TO: Mercedes-Benz Dealer Principals, General Managers, Sales Managers, Service Managers, Parts Managers	FROM: Gregory Gunther, Senior Manager, Vehicle Compliance and Analysis, Engineering Services
RE: <b>Recall Campaign Launch Notification</b> <b>Check Pirelli Tires</b> <b>MY18-19 E-Class Coupe/Cabriolet (238 platform)</b>	DATE: February 21, 2025

Campaign No. 2025010008, February 2025

SUBJECT: **Model E-Class (238 platform)**  
**Model Year 2018 – 2019**

## **Check Pirelli Tires**

Figure 2 – Not OK specified pressure (340 kPa)

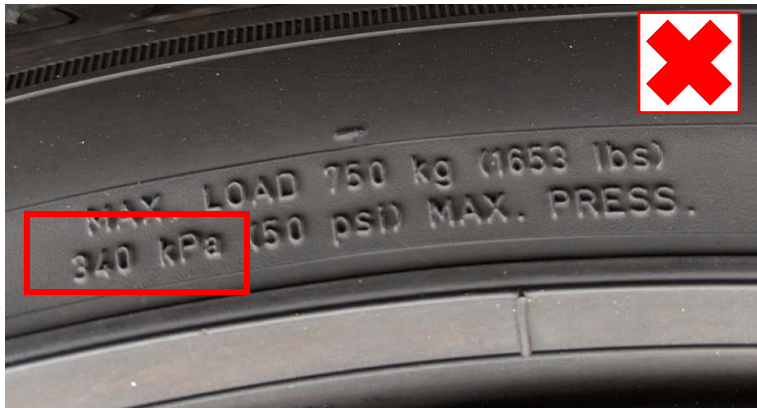
- a. If the above-mentioned tires have a **340 kPa (50 PSI)** (**Figure 2**) inscription on the side wall: Perform **Work Procedure**.
- b. If the above-mentioned tires have a **350 kPa (51 PSI)** (**Figure 3**) inscription on the side wall: Do **not replace** tires and **End Measure**.

2. All tires with dimension 245/45 R18 100Y XL MOE **with** inscription **340 kPa (50 PSI)** on the side wall **are to be replaced**.
